FALCON ACRES EL PASO COUNTY CONSTRUCTION DRAWINGS AUGUST 2023

PCD FILING NO.: SF223

CONSTRUCTION PLANS
COVER SHEET

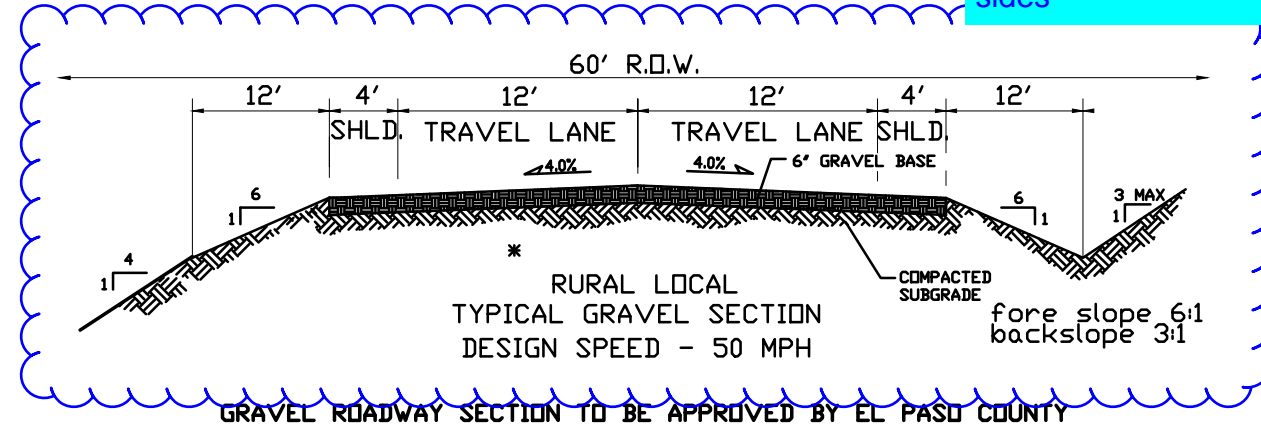
Add and call out 5ft easements on both sides

DUAL 36" RCP CULVERTS W/
FES SEPARATION DETAIL

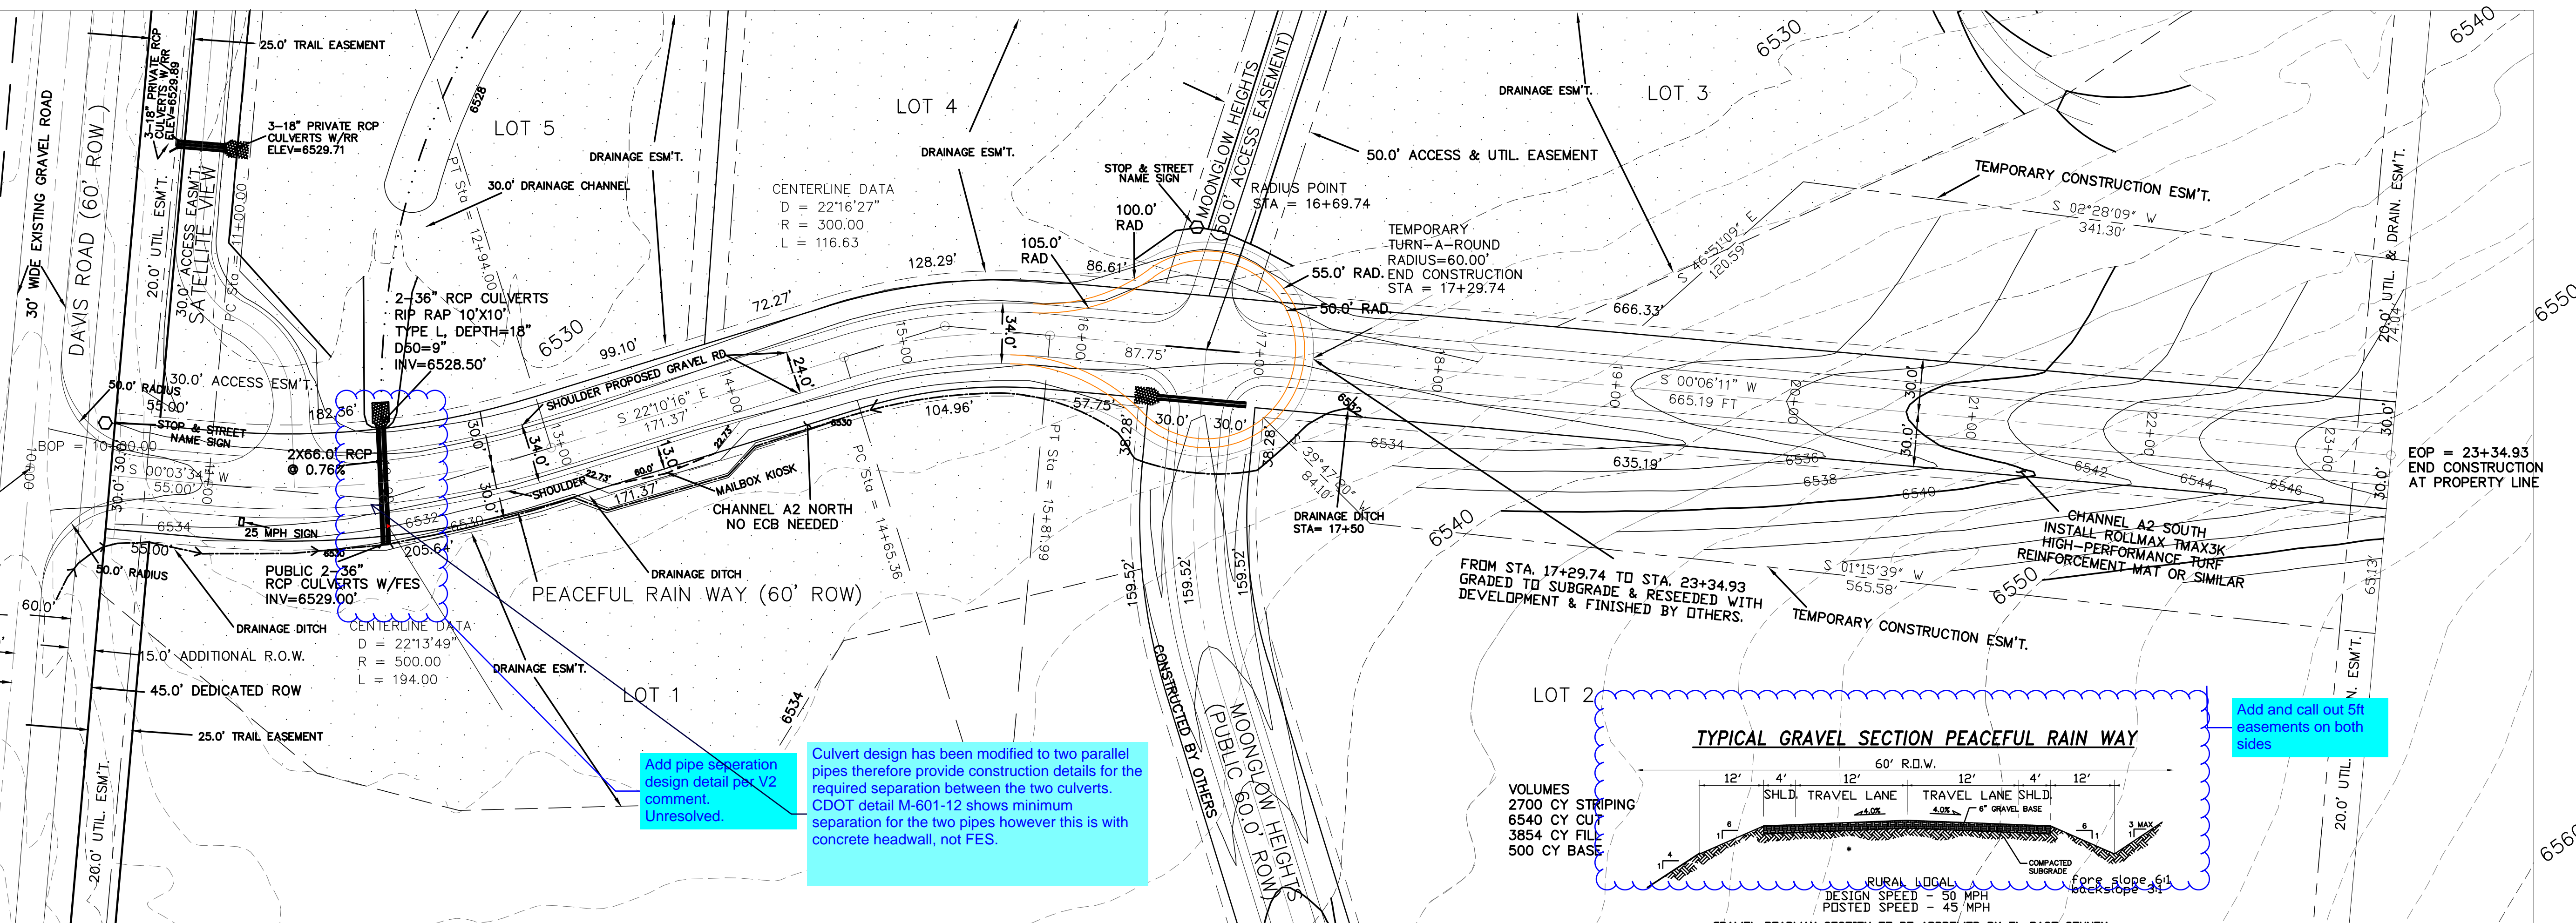
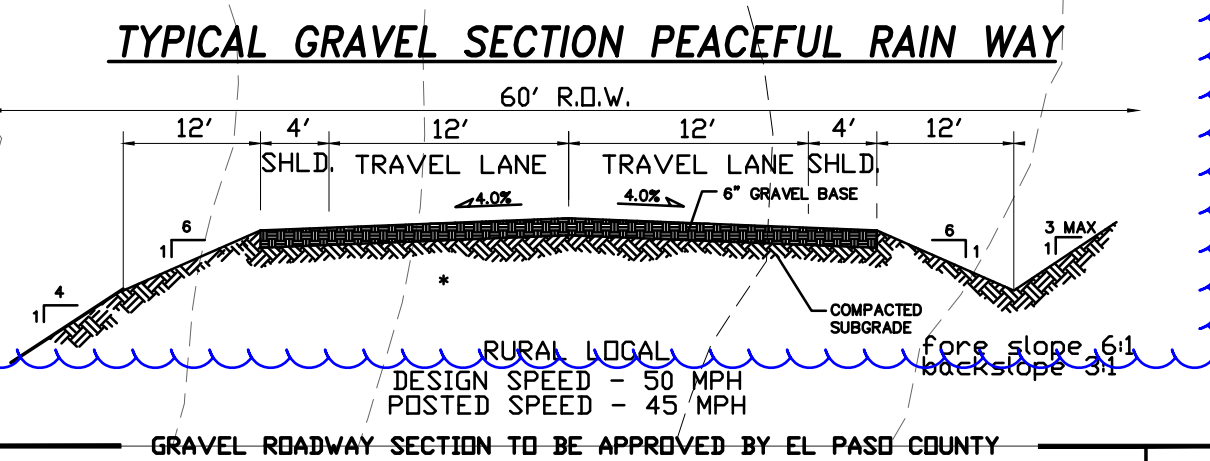
Add pipe separation design detail per V2 comment. Unresolved.

Culvert design has been modified to two parallel pipes therefore provide construction details for the required separation between the two culverts. CDOT detail M-601-12 shows minimum separation for the two pipes however this is with concrete headwall, not FES.

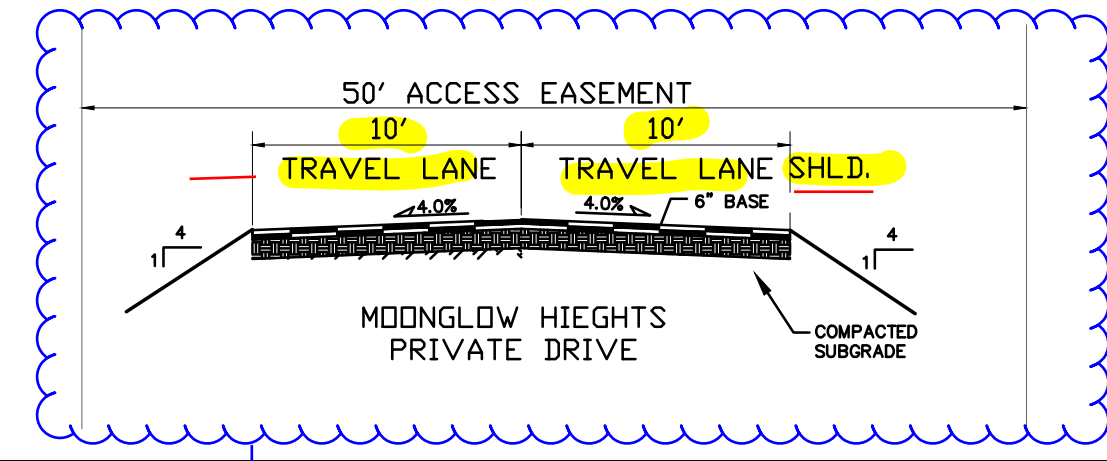
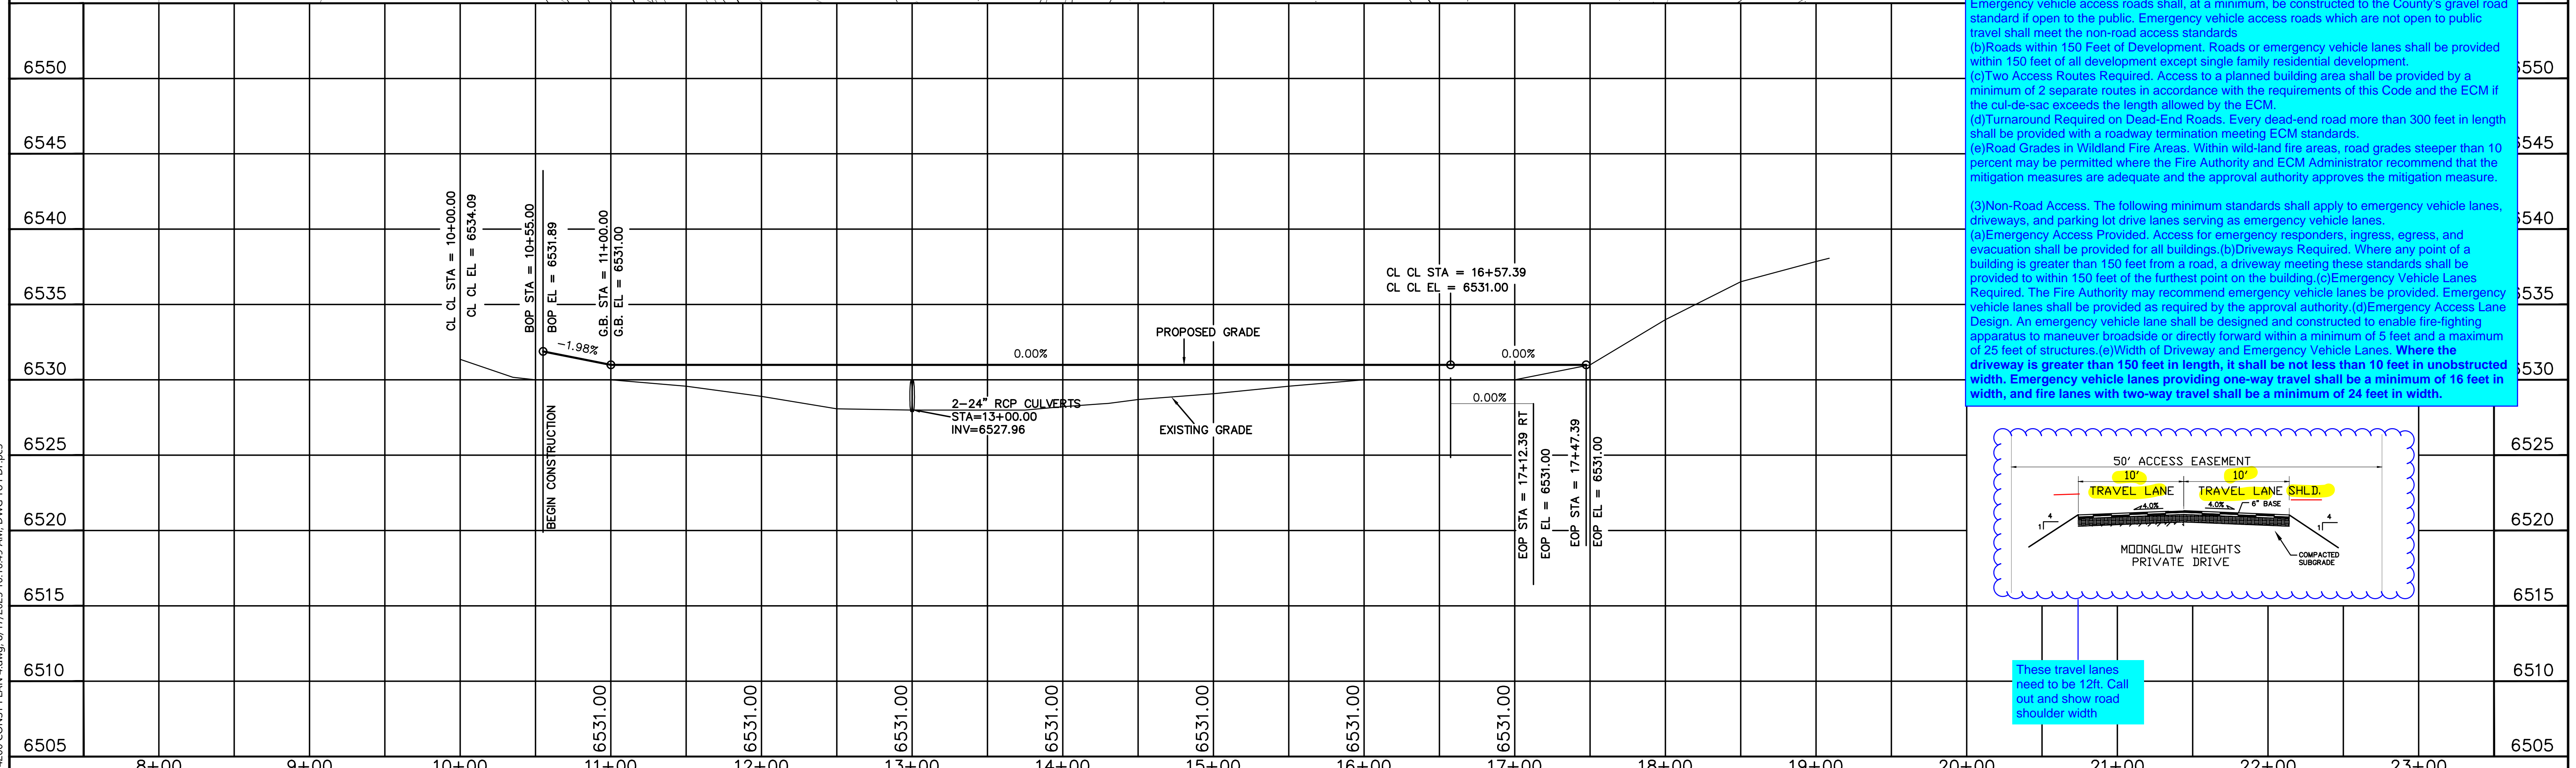
Ensure all ROW widths are consistent 60ft ROW with x2 5ft easements

NO.	DESCRIPTION	DATE										721 S. 23RD ST. COLORADO SPRINGS, CO 80904 OFFICE: 719-635-6422 FAX: 719-635-6426 www.tresinc.com		PROJECT: MOONGLOW HEIGHTS FROM: 10+00.00 TO: 17+47.40 SUBDIVISION: FALCON ACRES DRAINAGE BASIN: _____ JOB NO.: 2142.00 SHEET: 4 OF 13	
NO.	DESCRIPTION	DATE

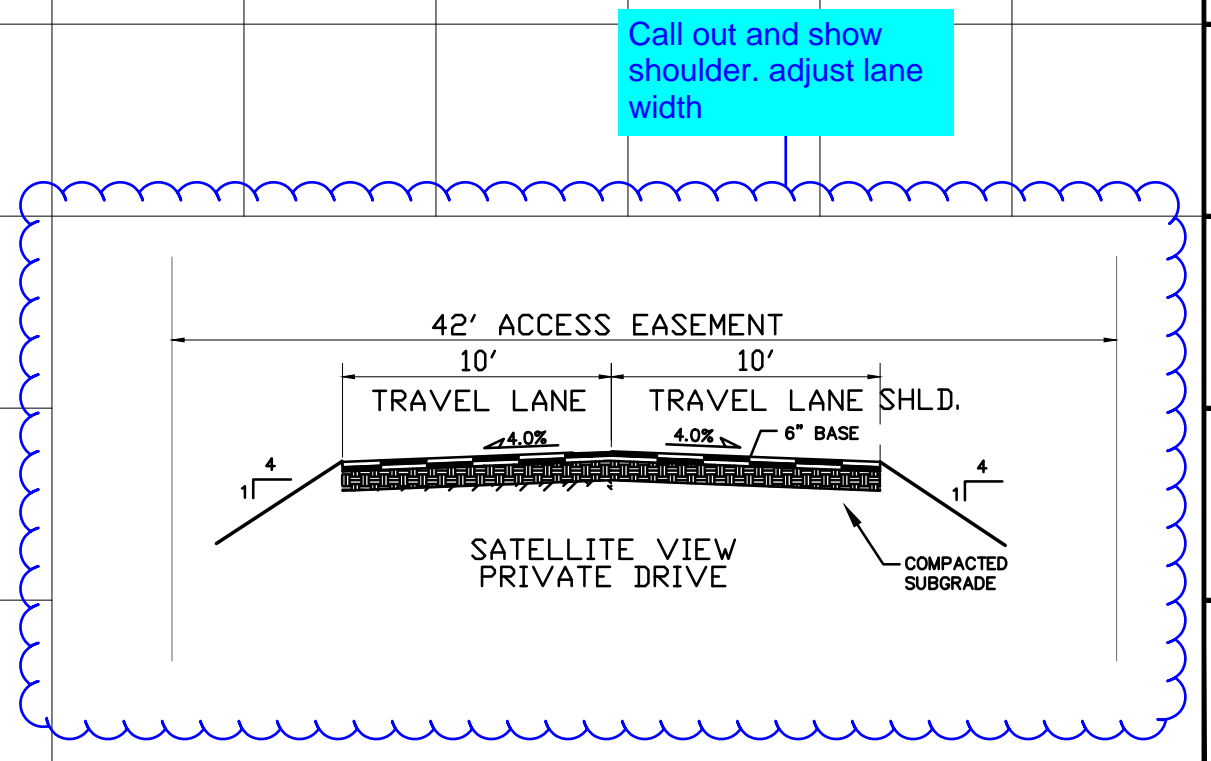
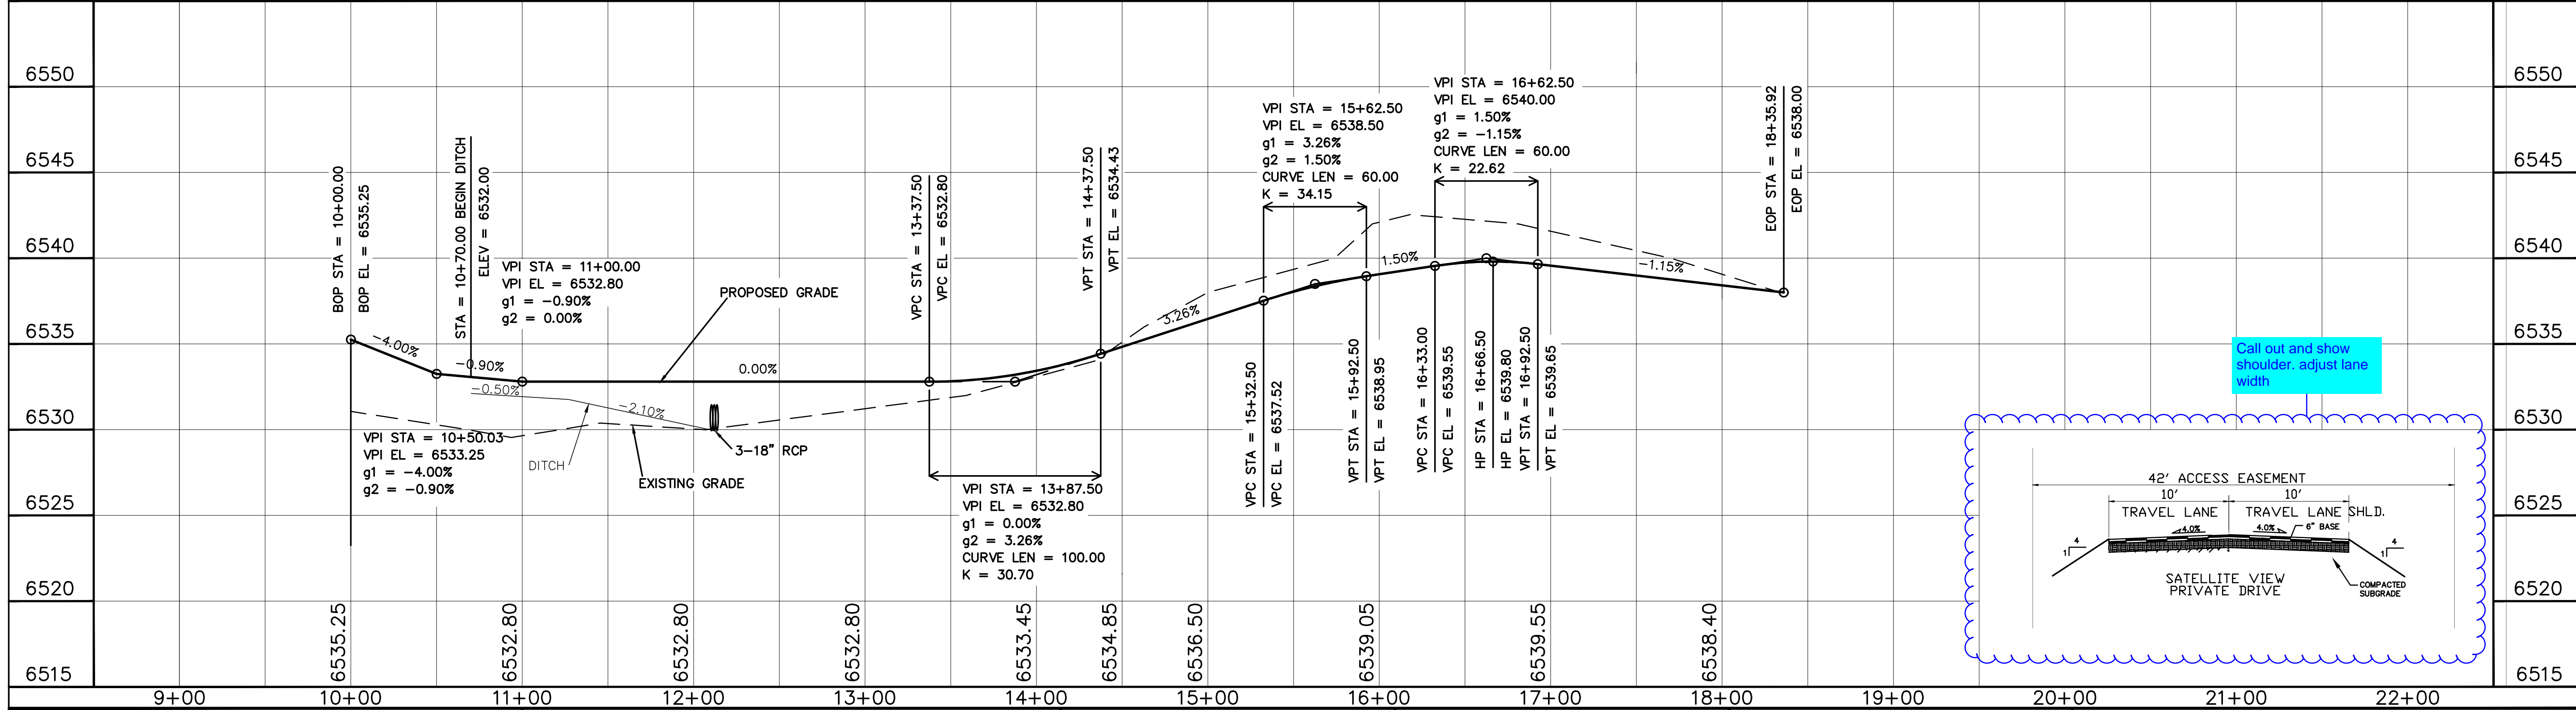
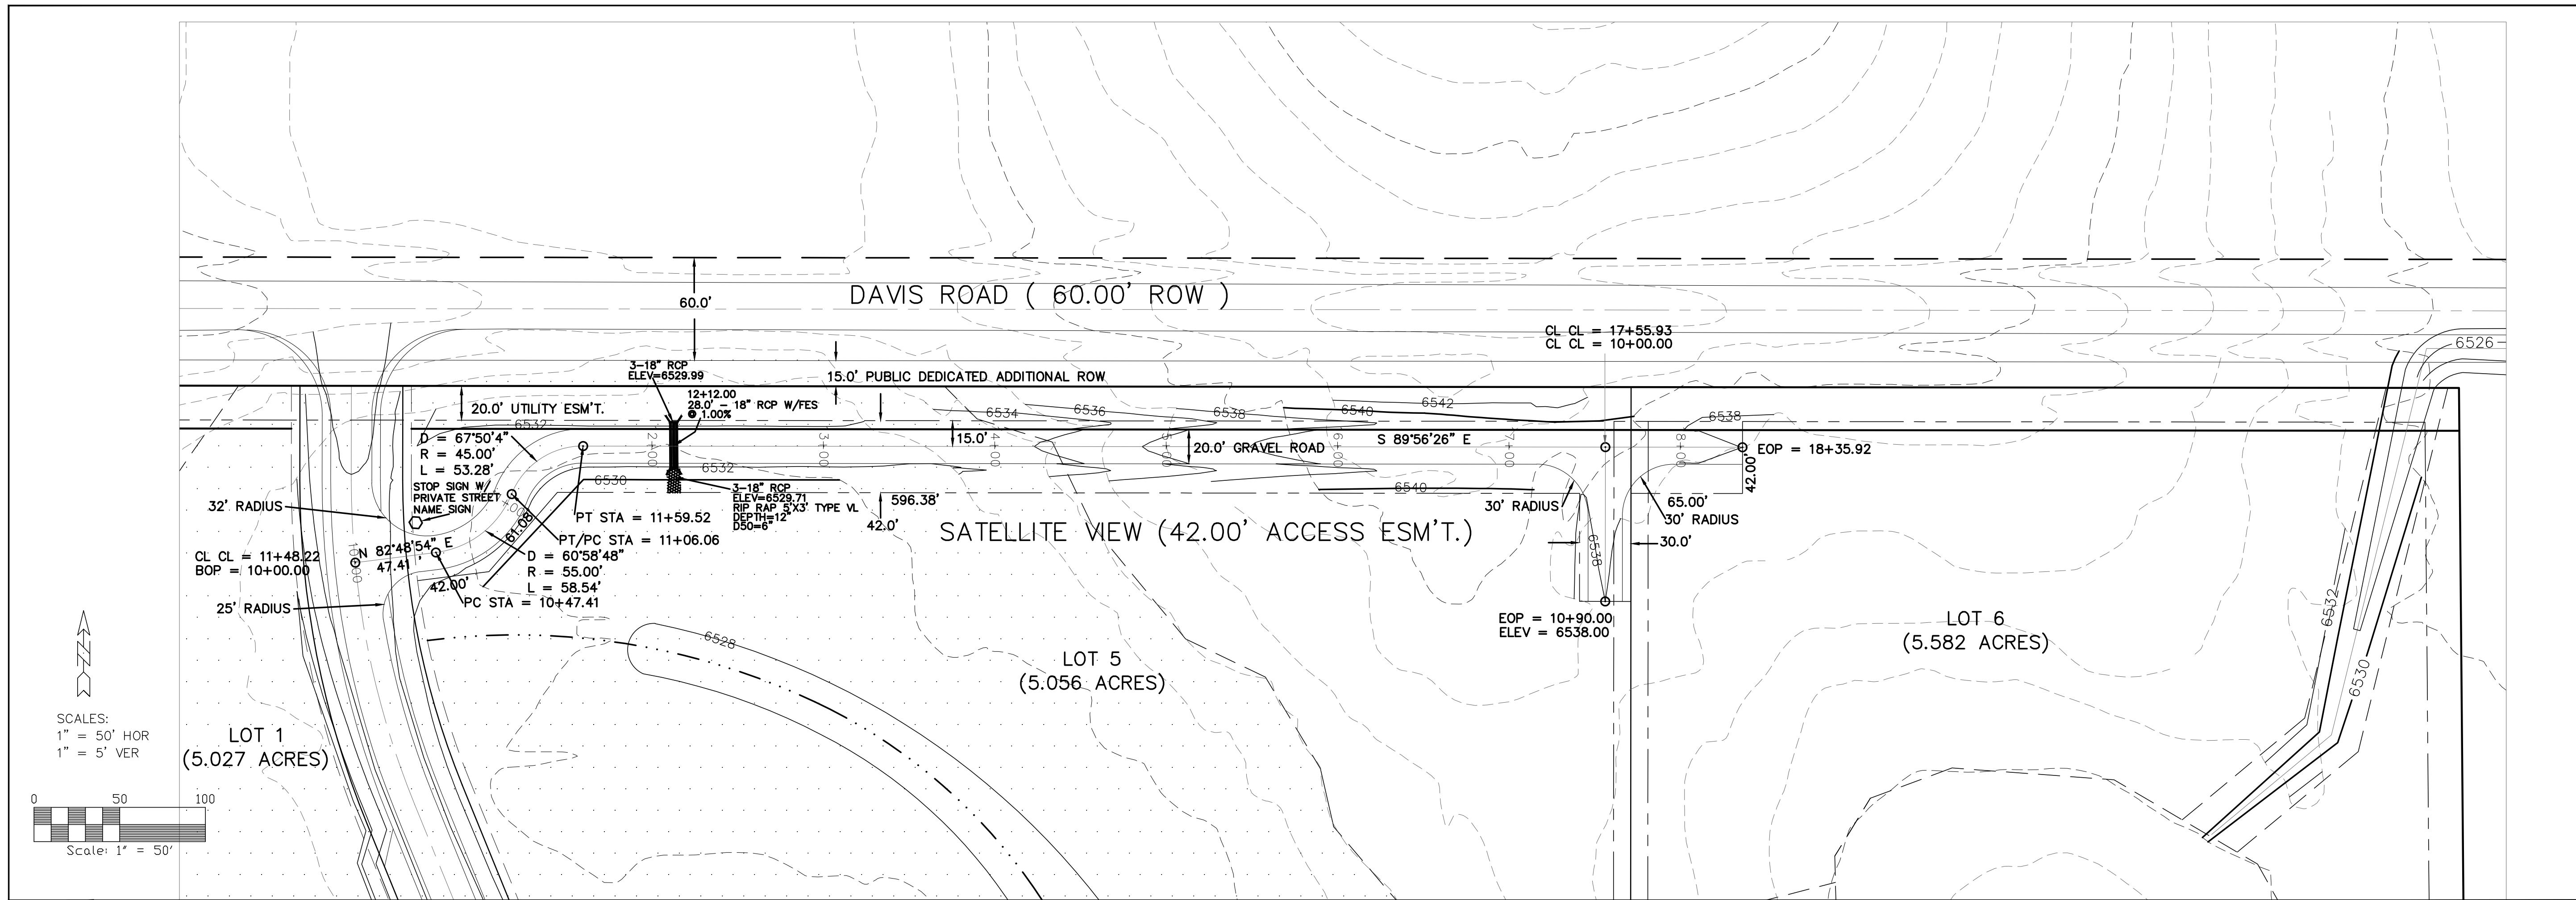
These travel lanes need to be 12ft. Call out and show road shoulder width
